TECHNICAL NOTE

Project Title: Beane Solar Farm

Report Reference: 794-PLN-TRP-JNY11727-04

Beane Solar Farm Technical Note

Appendix 5 – HGV Swept Path Analysis

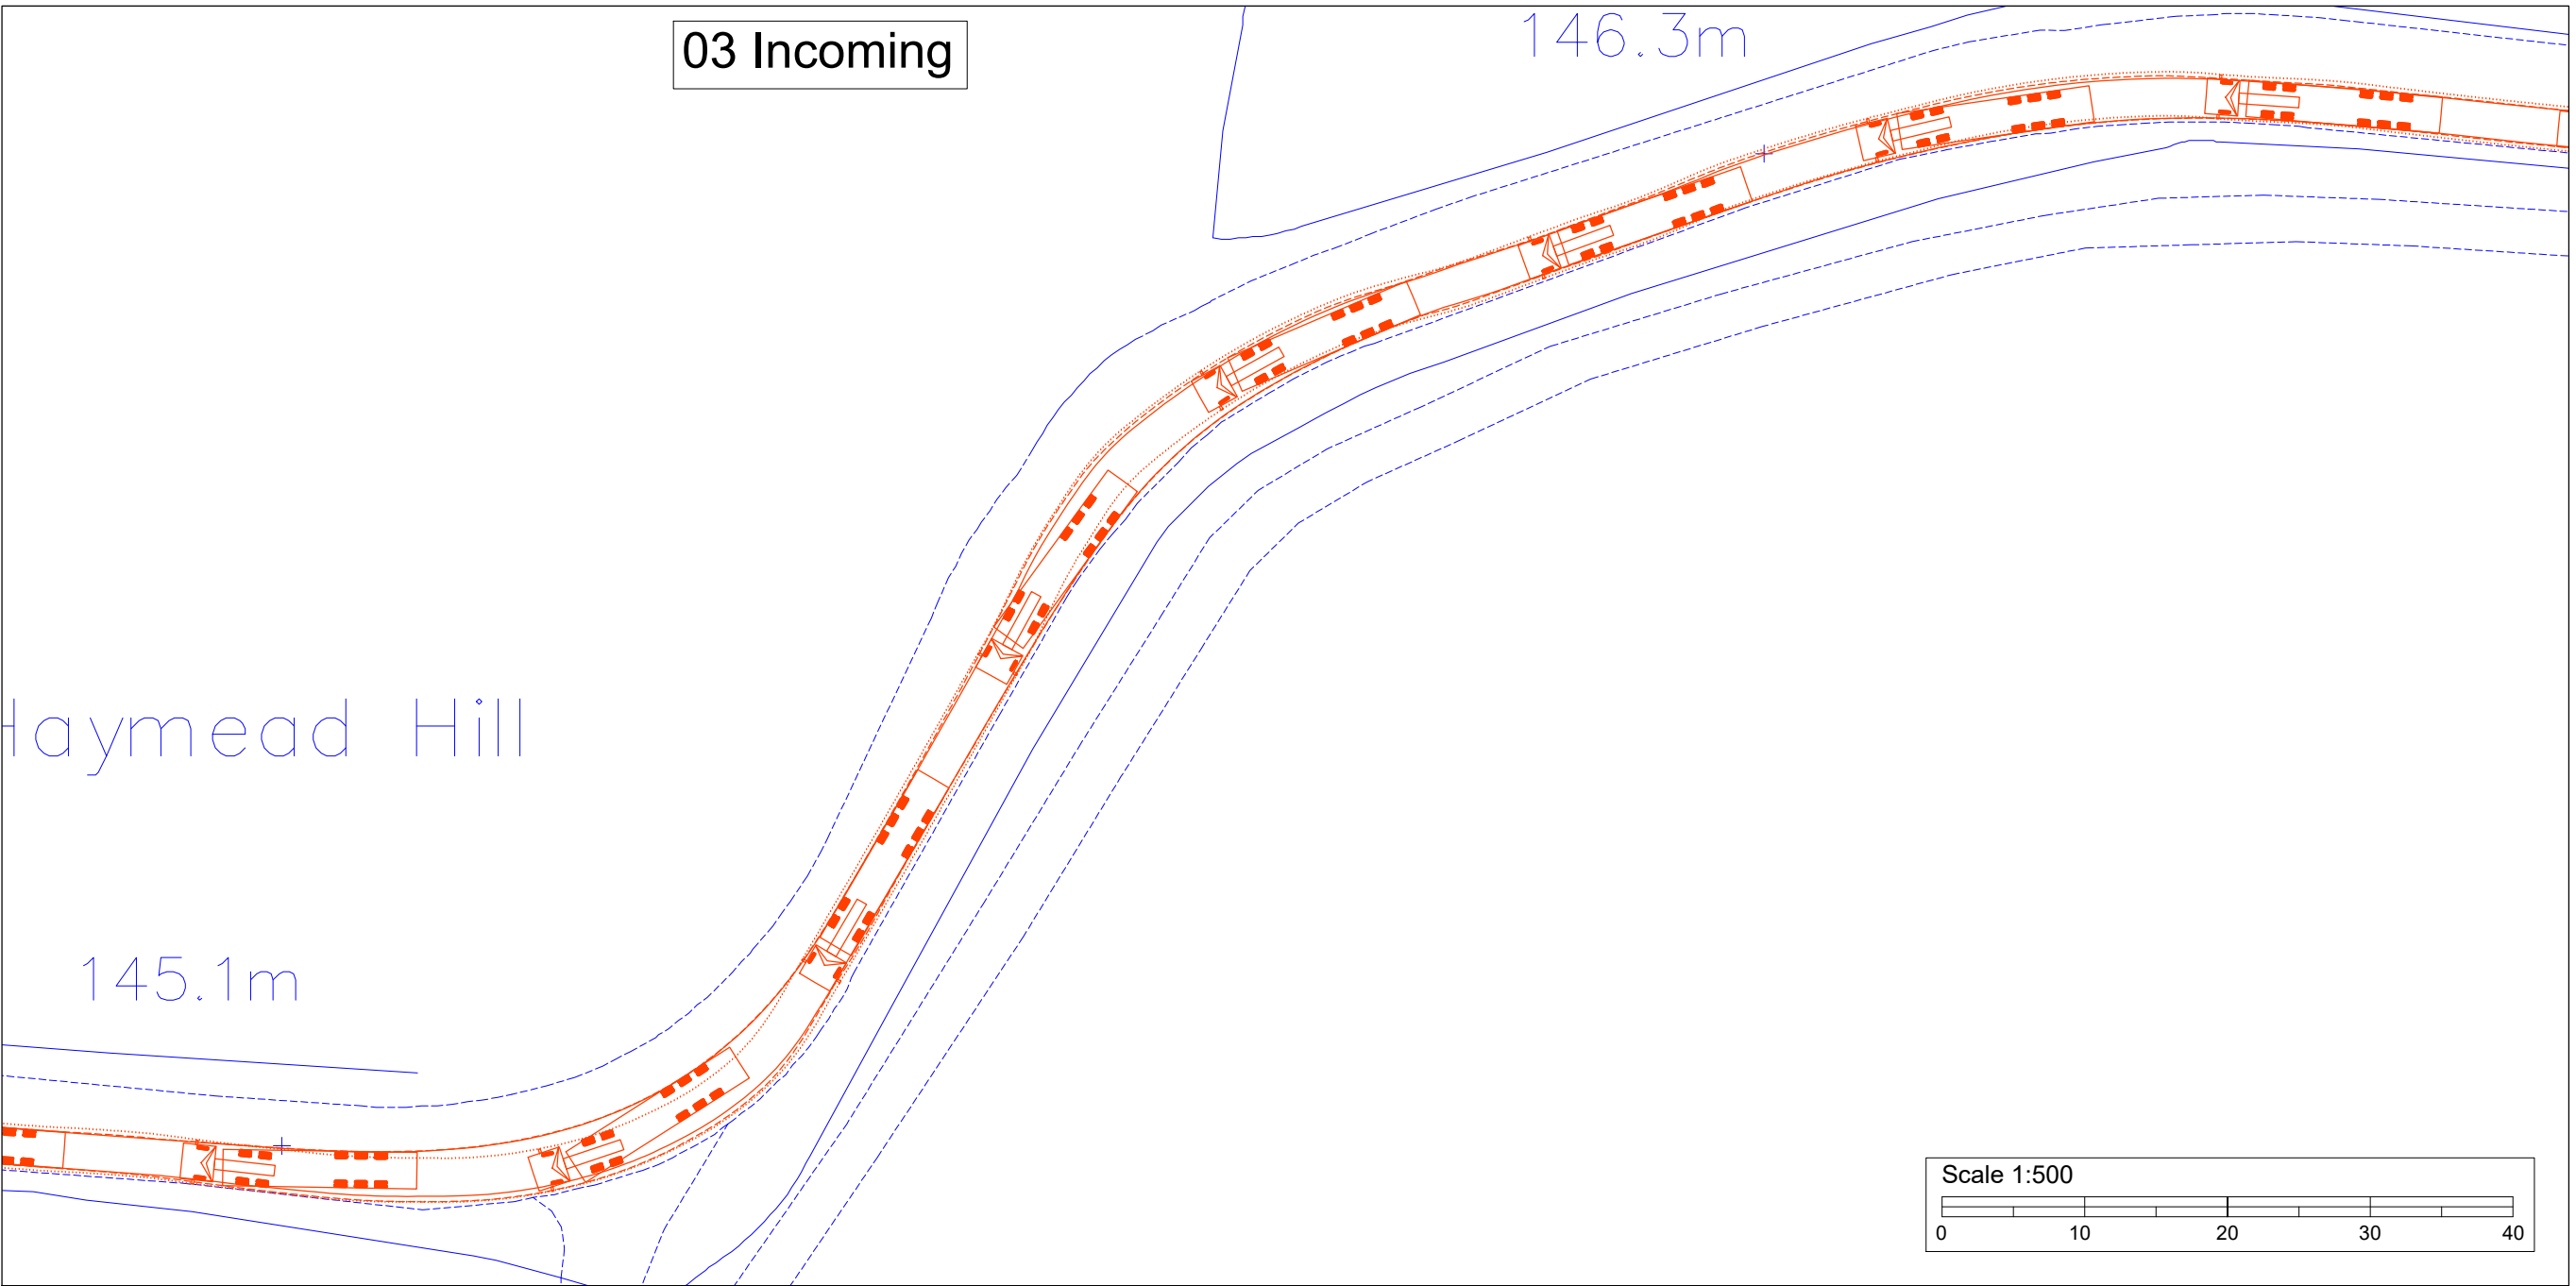
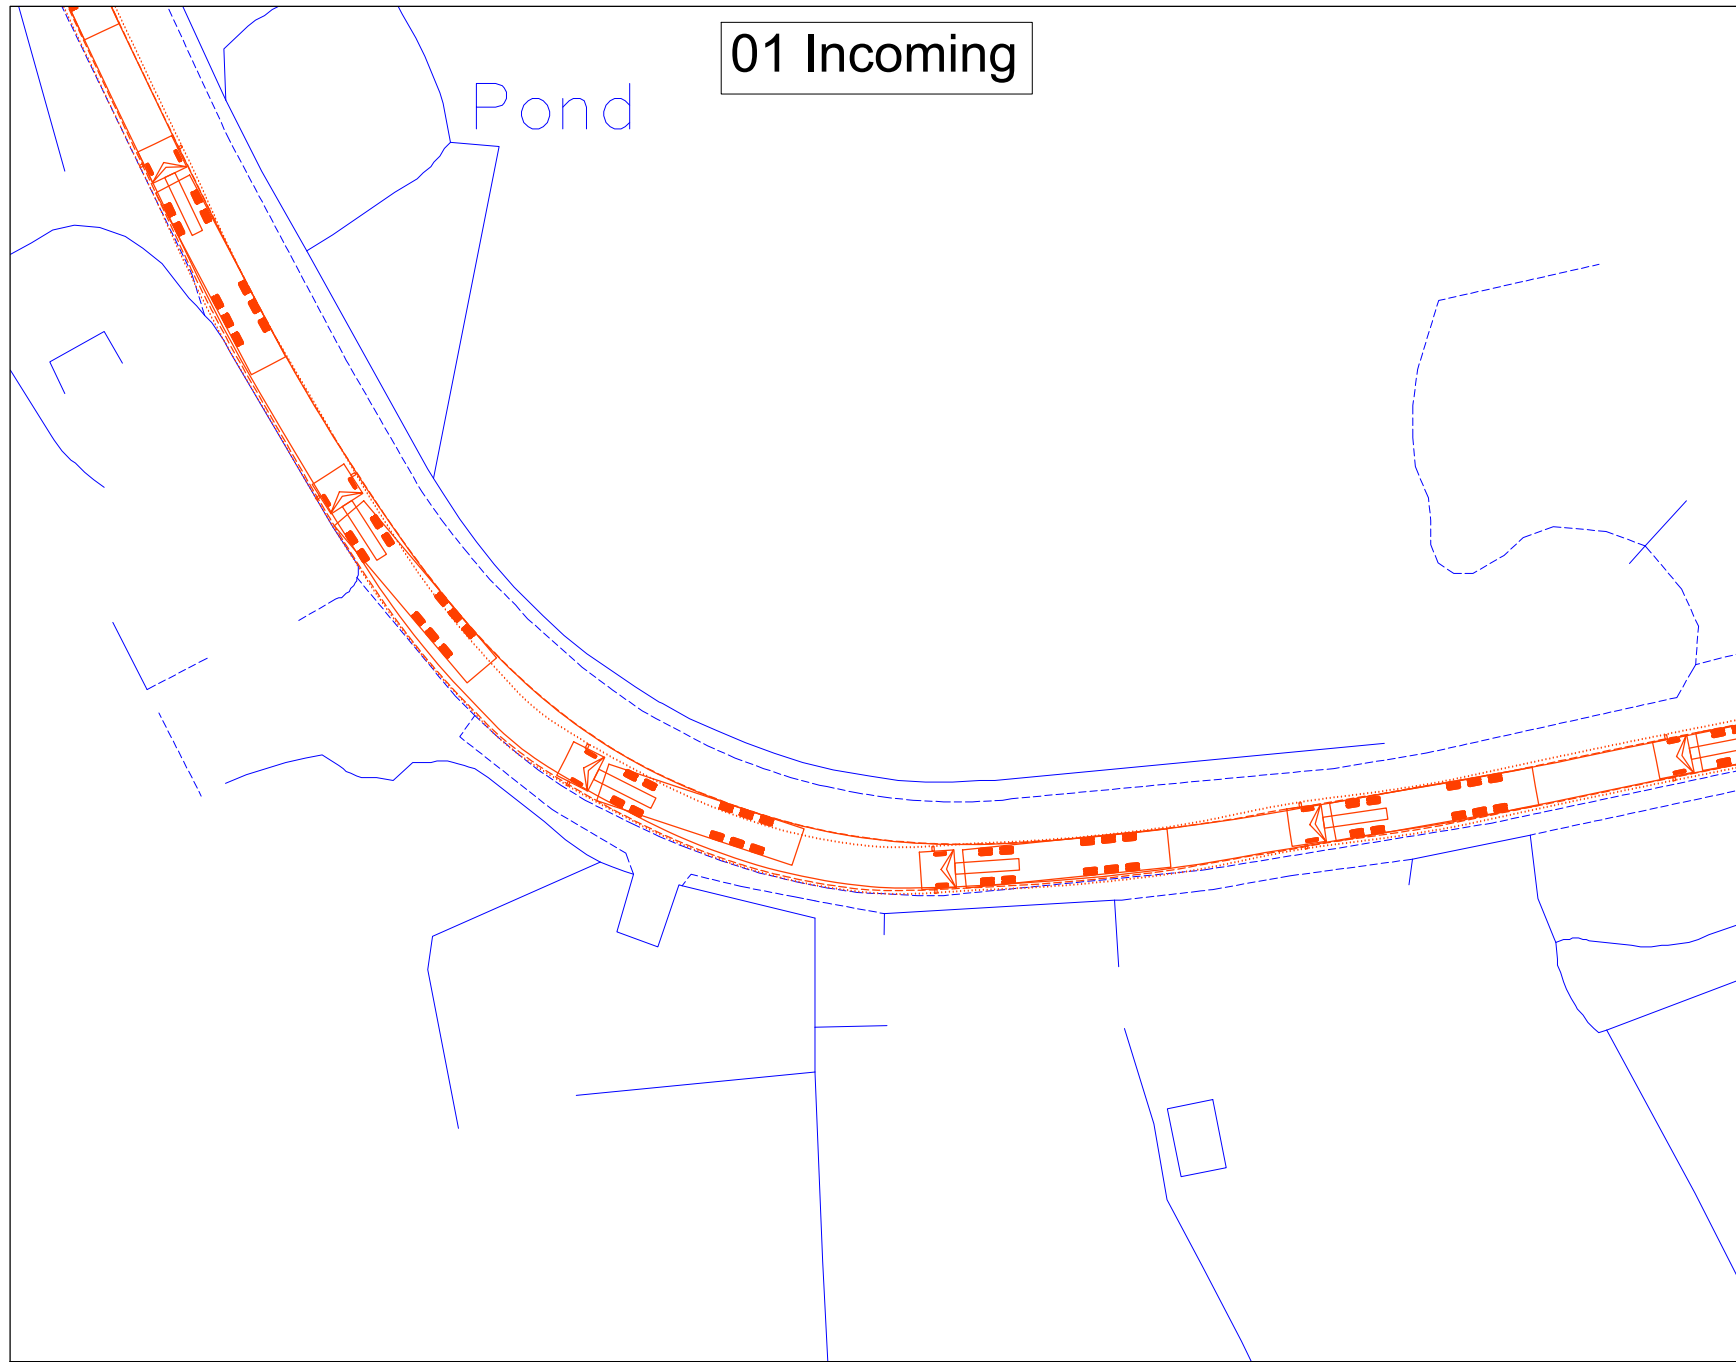
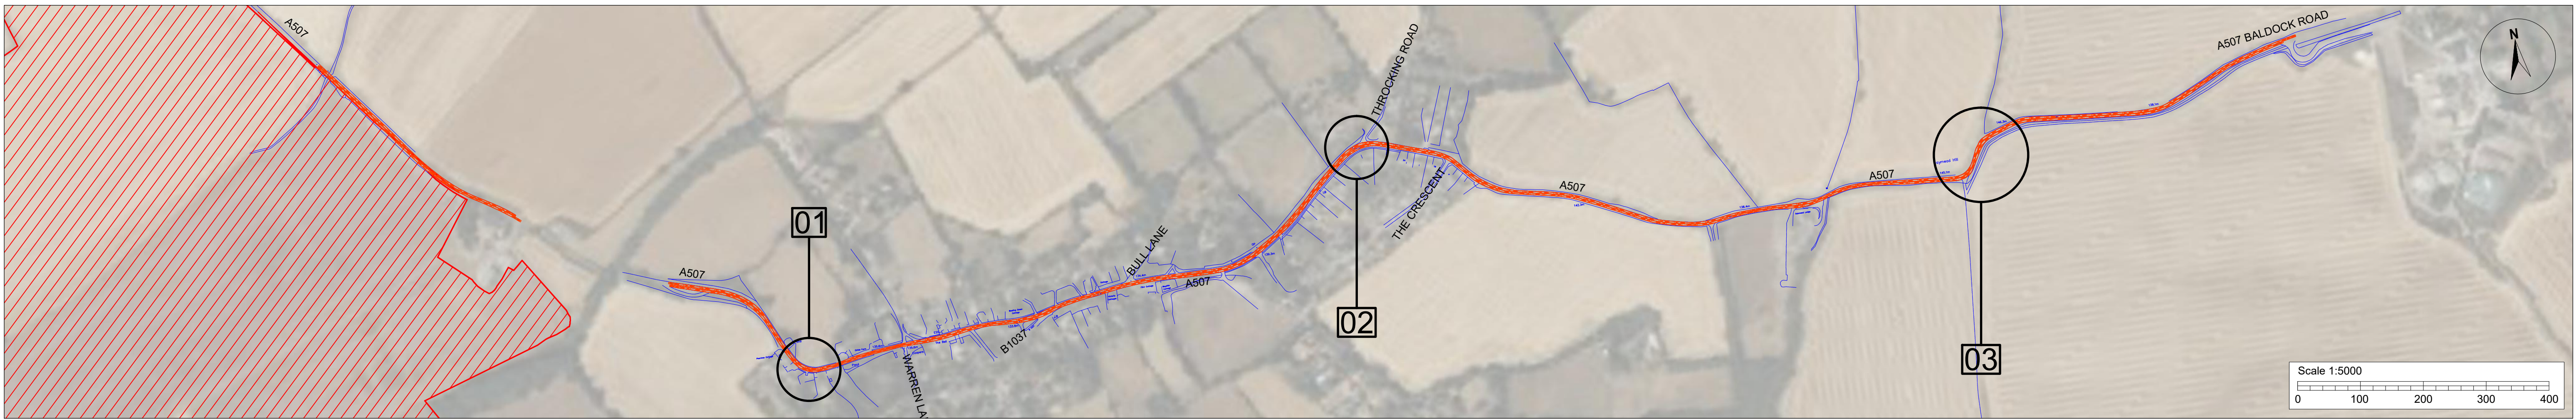
- Drawing number 05003-RES-ACC-DR-PE-003 Rev 1 and 05003-RES-ACC-DR-PE-004 Rev 1 illustrates a 16.5 metre lorry entering from Cromer Heath which is not suitable for such a vehicle. The CMP says that this access will not be used by HGV's - this needs to be clarified.

- 1.27 Paragraph 4.5 of the CTMP states that construction materials will all enter the site via the A507 access into the northern parcel, and materials designated for the southern parcel will be transhipped onto smaller vehicles (e.g. tractor and trailers, or light goods vehicle) within the temporary construction compound (west from the A507). From here, they will be moved internally within the site, and to the southern compound for storage and transit between the northern and southern land parcels via tractor and trailer along Cromer Heath. This approach will reduce / minimise the distance travelled by construction HGVs along constrained sections of the public highway, and appropriate traffic management measures can be adopted where necessary.

- 1.28 A swept path of a tractor and trailer moving through the southern access, to and from the north, is shown at **Appendix 4**.
